ADVISORY
 BULLETIN

No. 2001-06

Official Notification Federal Boat Safety Act Flywheel Nut Retorque - 115 EFI Four Stroke

Factory Crankshaft and Nut Yellow Mark.

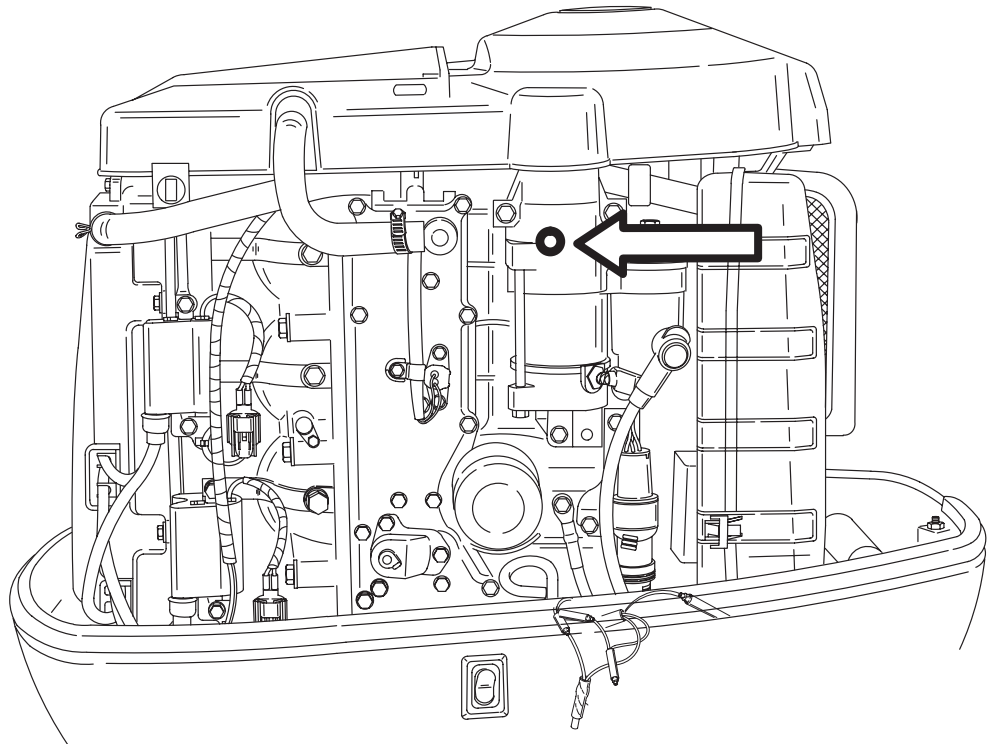
Outboards produced previous to serial number 0T388253 should be inspected for the yellow mark on the end of the crankshaft and flywheel nut or the yellow mark on the starter housing. There are additional color (white and red) marks on the end of the crankshaft and flywheel nut that are applied for other manufacturing aids.

Outboards with yellow marks have been reworked at Mercury Marine and do not require the retorque.

Outboards without the yellow marks require retorquing of the flywheel nut.

Starter Motor Dot.**Correction**

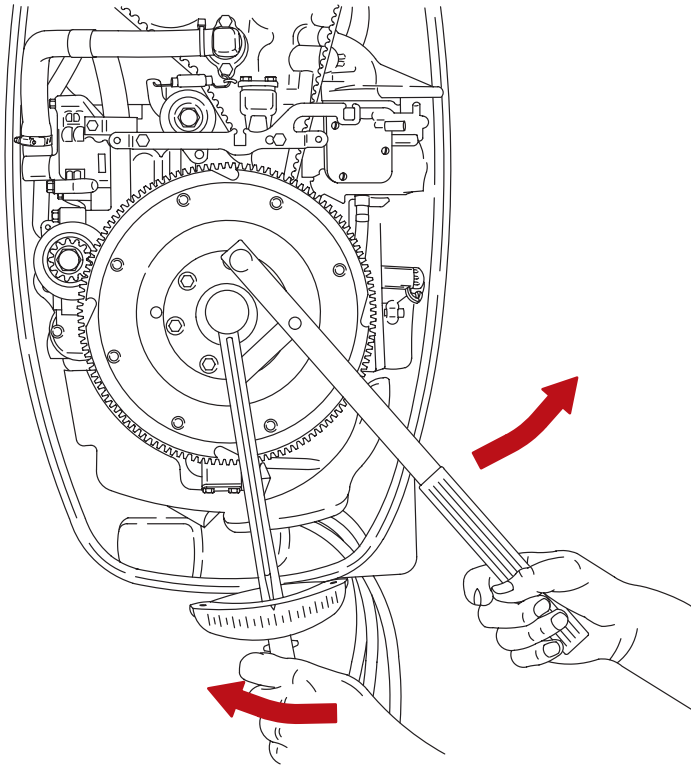
Outboards without the yellow marks within the serial number range of OT332305 through OT388252 require retorquing of the flywheel nut.

Torque Flywheel Nut to 140 lb-ft (189.8 N m)

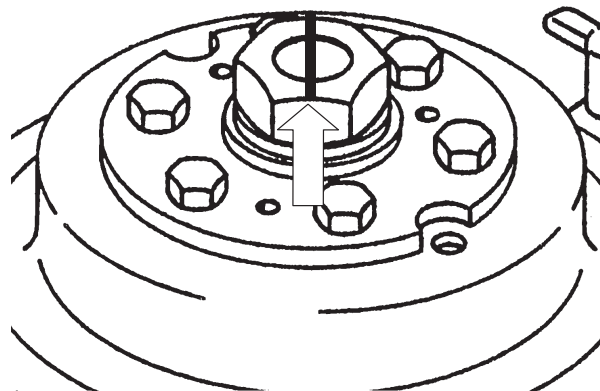
2. Retorque the flywheel nut to 140 lb-ft. (189.8 N·m) with a torque wrench.

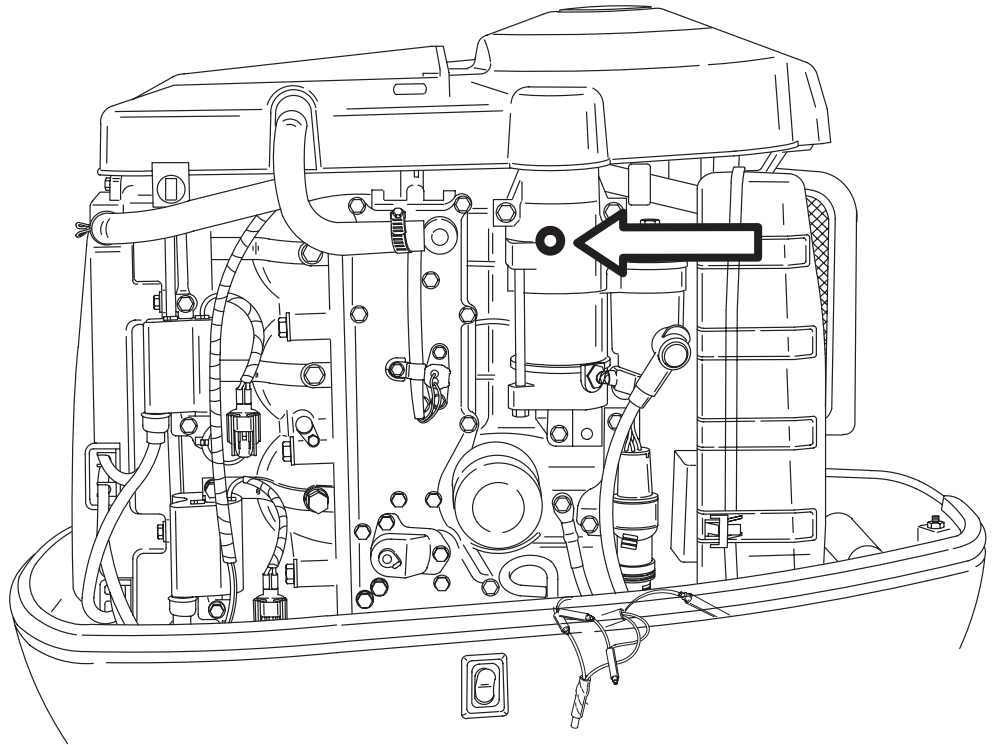
3. Mark a black line on the end of the crankshaft and both flywheel nut surfaces.
